RE: Presbyterian Healthplex Pool Addition
6301 Forest Hills Dr. NE
Grading and Drainage Plan Stamp Date: 9/17/20
Hydrology File: E18D036

Re: Presbyterian Healthcare Services Healthplex Pool Addition – Hydrology Resubmittal:
Hydrology File: E18D036

GRADING &
DRAINAGE PLAN

C101
OF

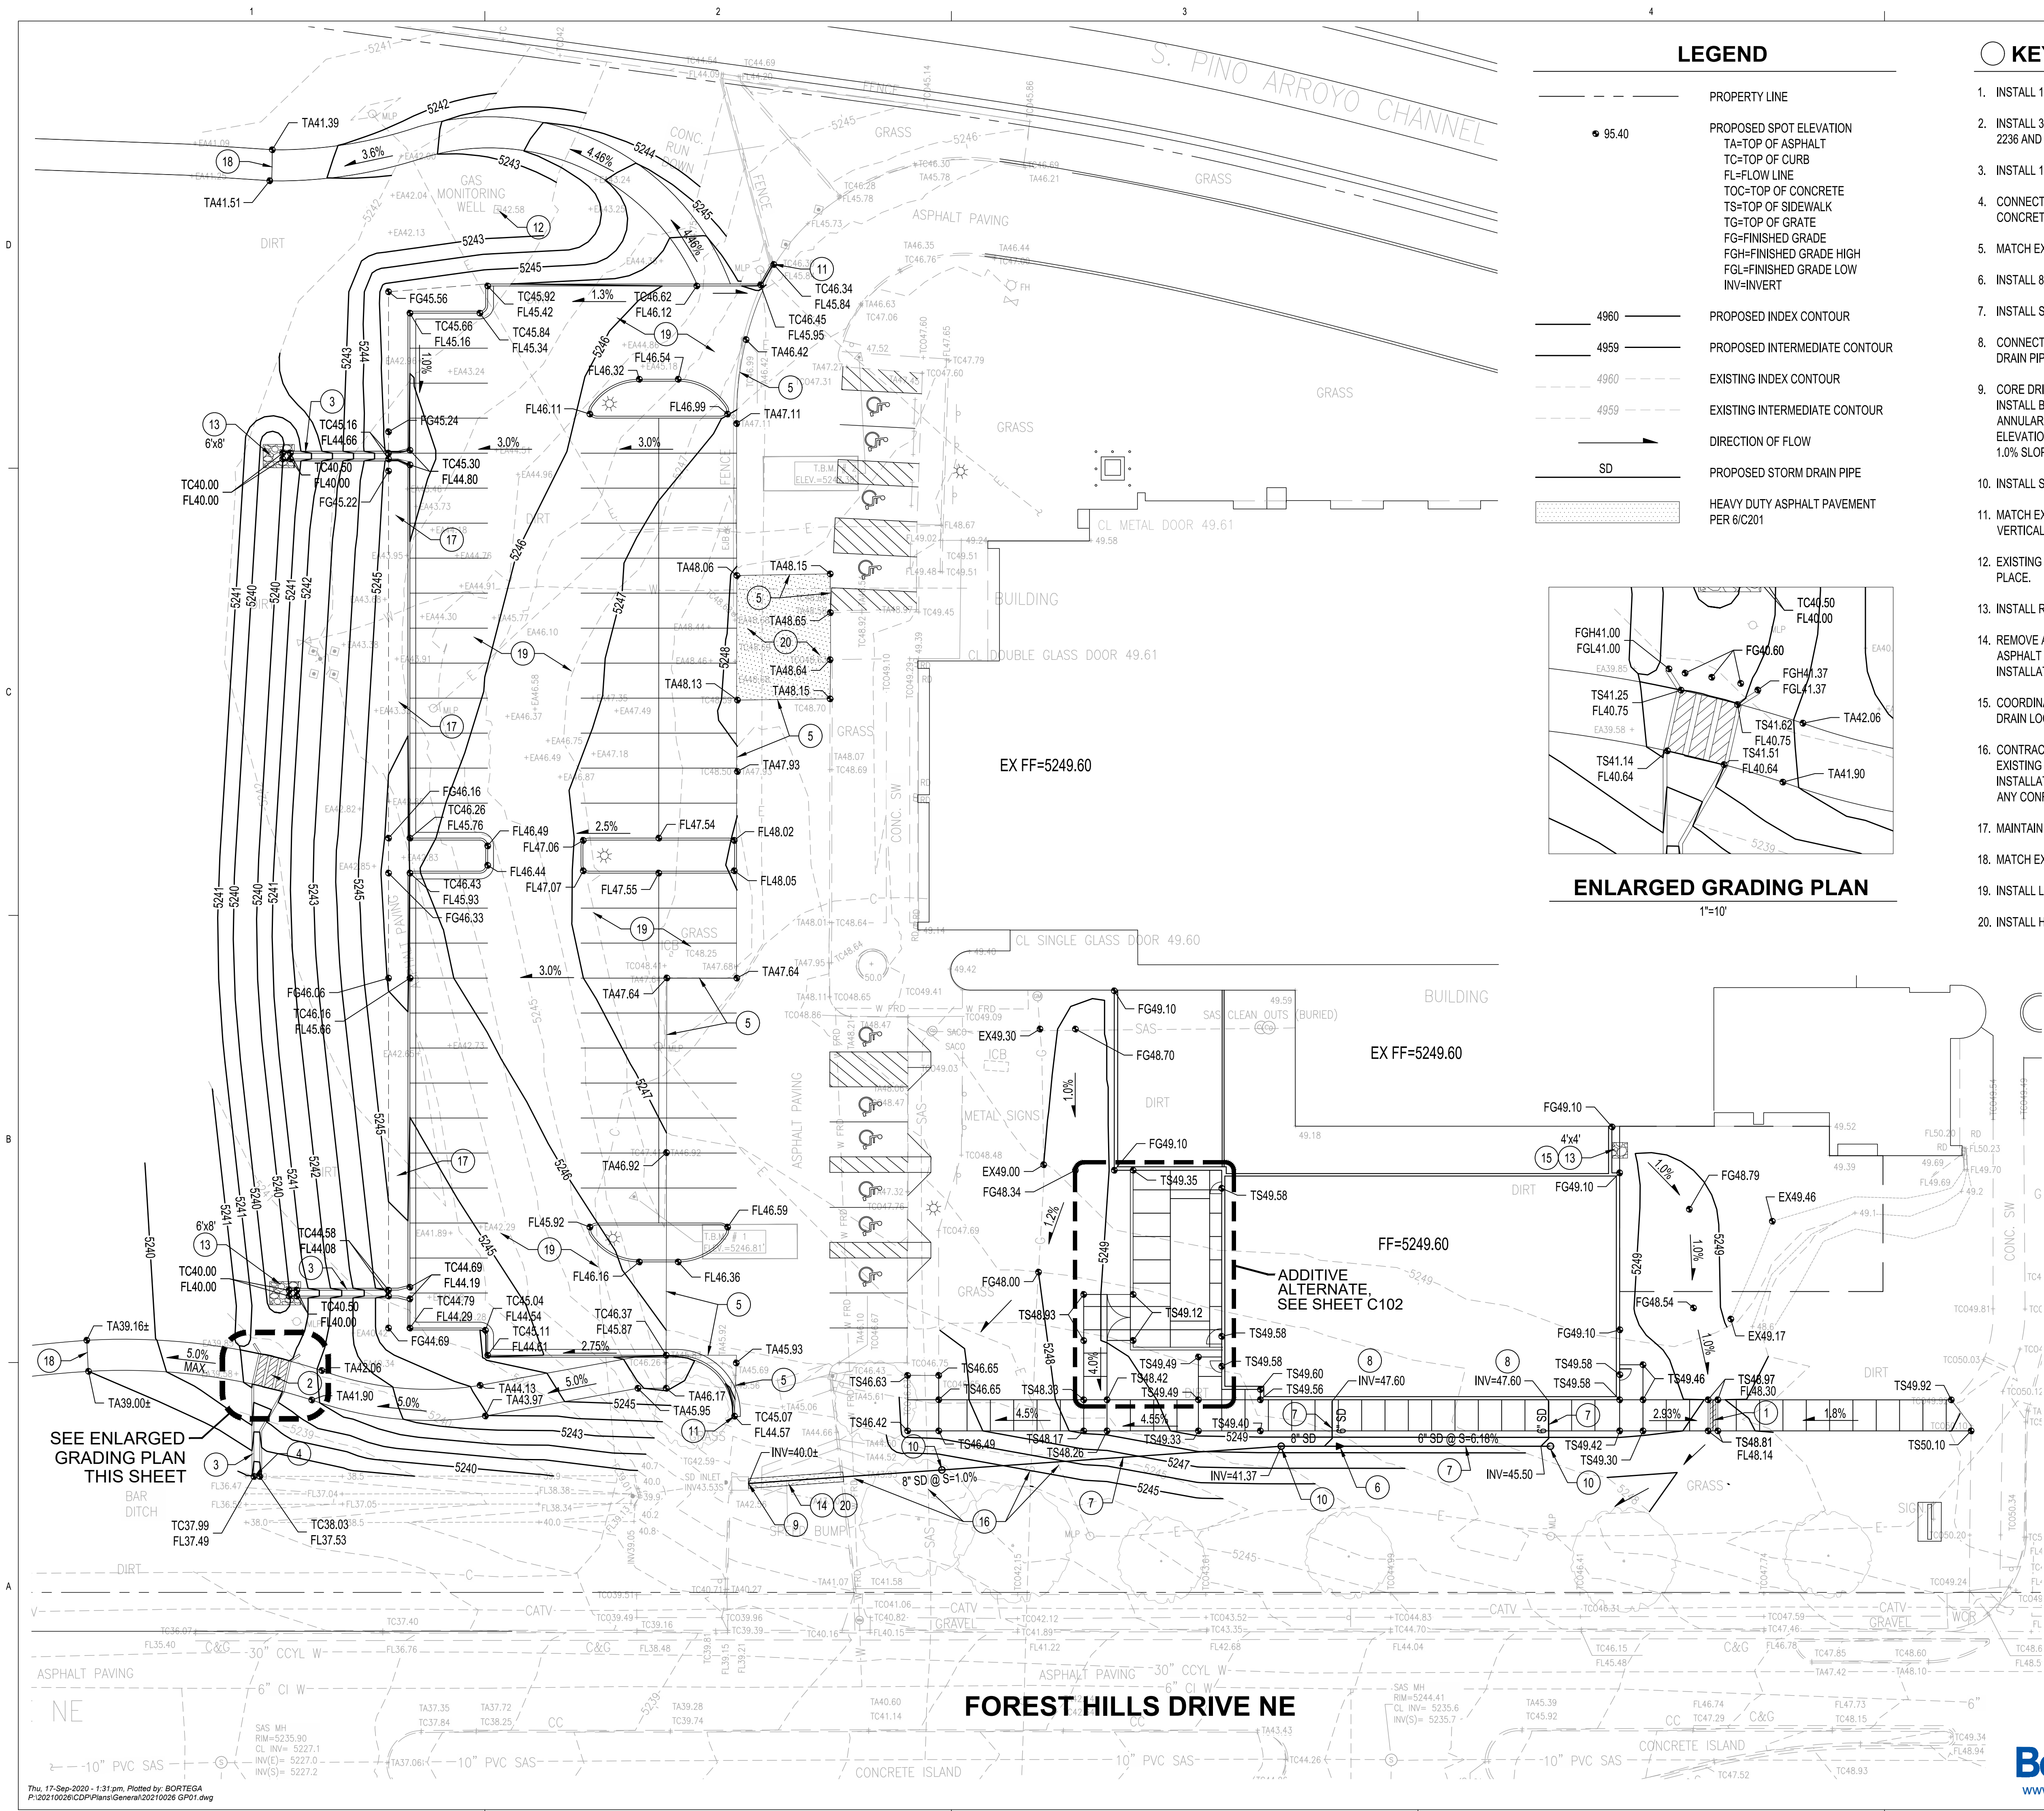
1. On the Proposed Drainage Management Plan sheet, the width for rundown R3 is listed as 6.0 ft. but on sheet C101 it is listed as 18 inches wide. Please correct this and recalculate the channel capacity.

2. On sheet C102 the Additive Alternate Grading does not have any indication of where this is located. None of the other sheets provided show where this might be located either. Please indicate on sheet C101 where this is.

Response: The weir opening width (3-24" wide sidewalk culverts) controls the initial conveyance but beyond the weir the 18" channel has capacity to convey the flow. The table on the DMP addresses both weir and channel capacities. The sidewalk culvert and channel transitions to the 18" wide channel. Refer to Detail 2 on Sheet C201. This is correctly noted on C101 and detailed on C201.

Response: The bid alternate area has been noted on C101
